**From:** [Pui Ming Leung](#)  
**To:** [Committee of Adjustment \(SM\)](#)  
**Subject:** Comments, Enova Power, April 2025  
**Date:** Monday, May 5, 2025 9:51:20 AM  
**Attachments:** [11111.pdf](#)

The following are the comments for Committee of Adjustment applications - April 2025.

## CLEARANCES TO ADJACENT STRUCTURES 8.32KV - 27.6KV

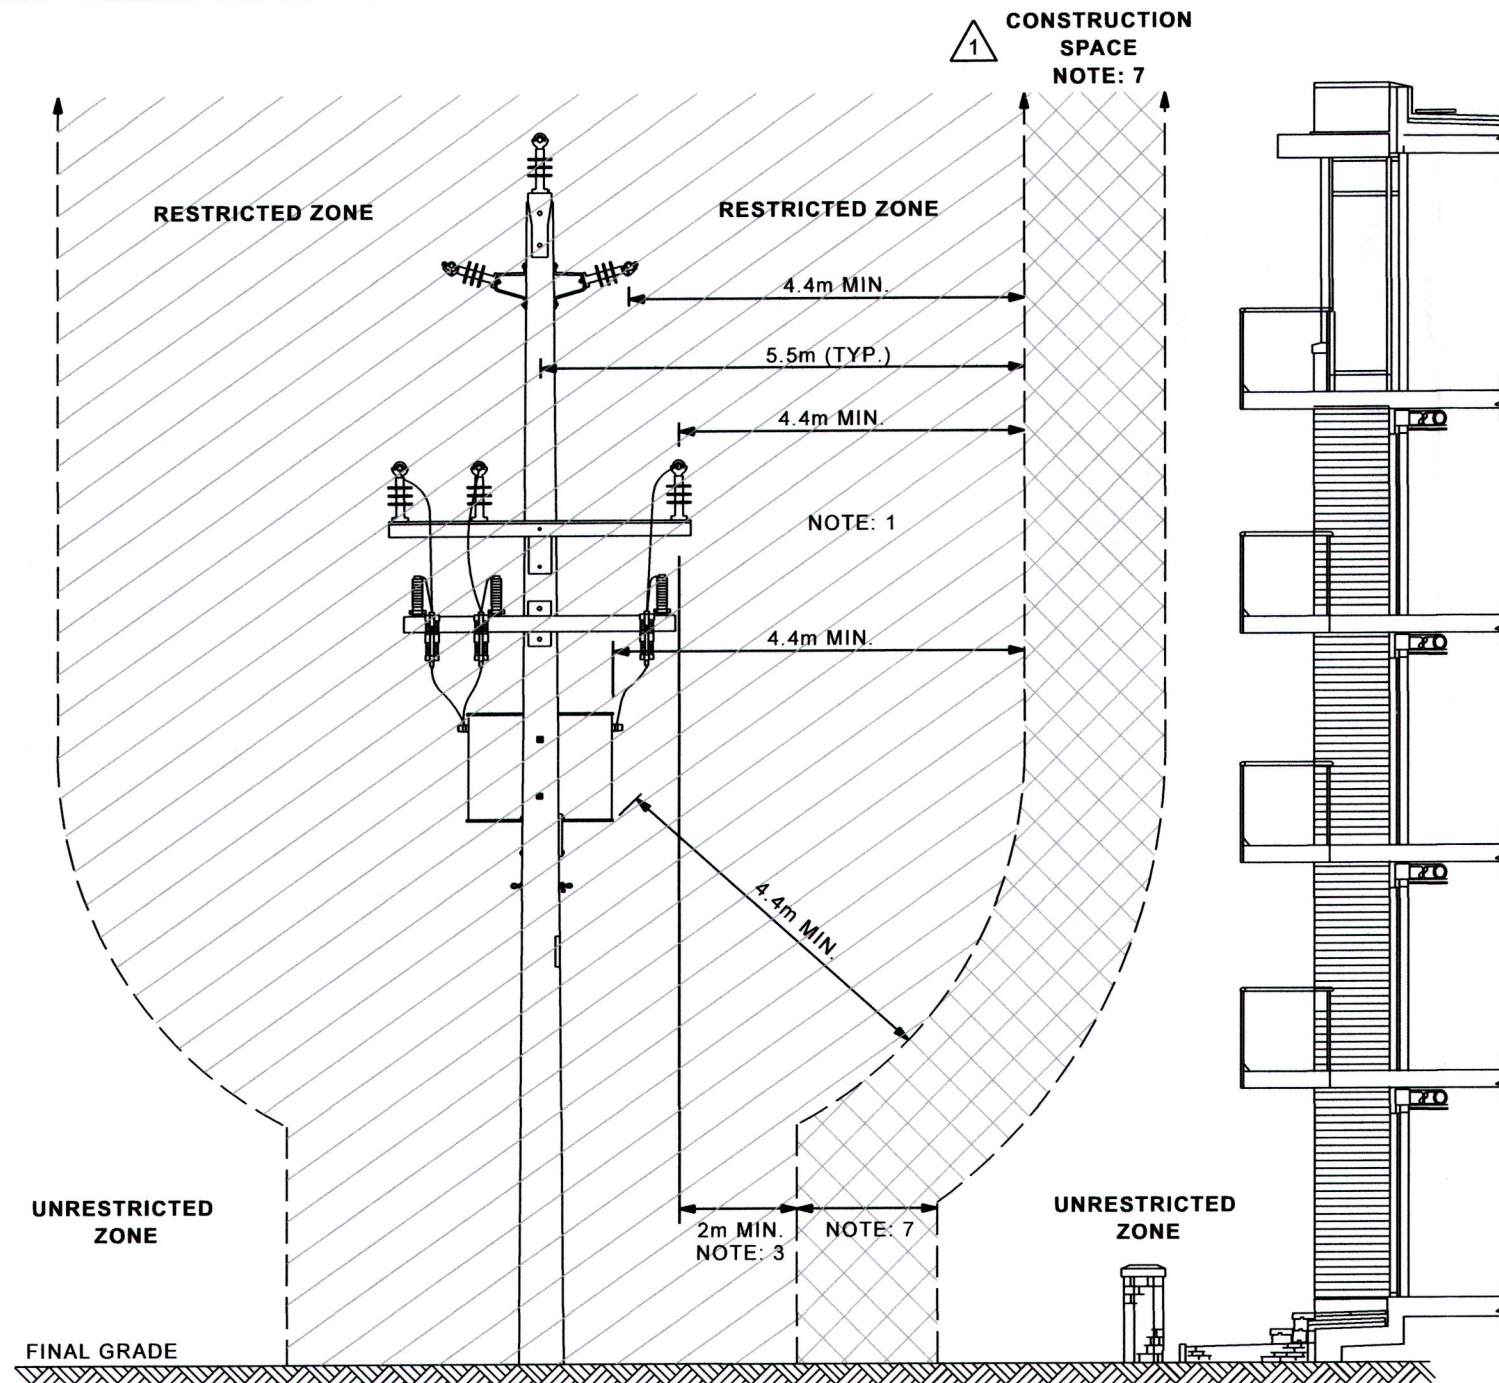
The building must maintain a minimum clearance of 5.5 meters plus required working space from the primary hydro pole line. Refer to Standard D11111 for guidance. Additional requirements can be found in the document:
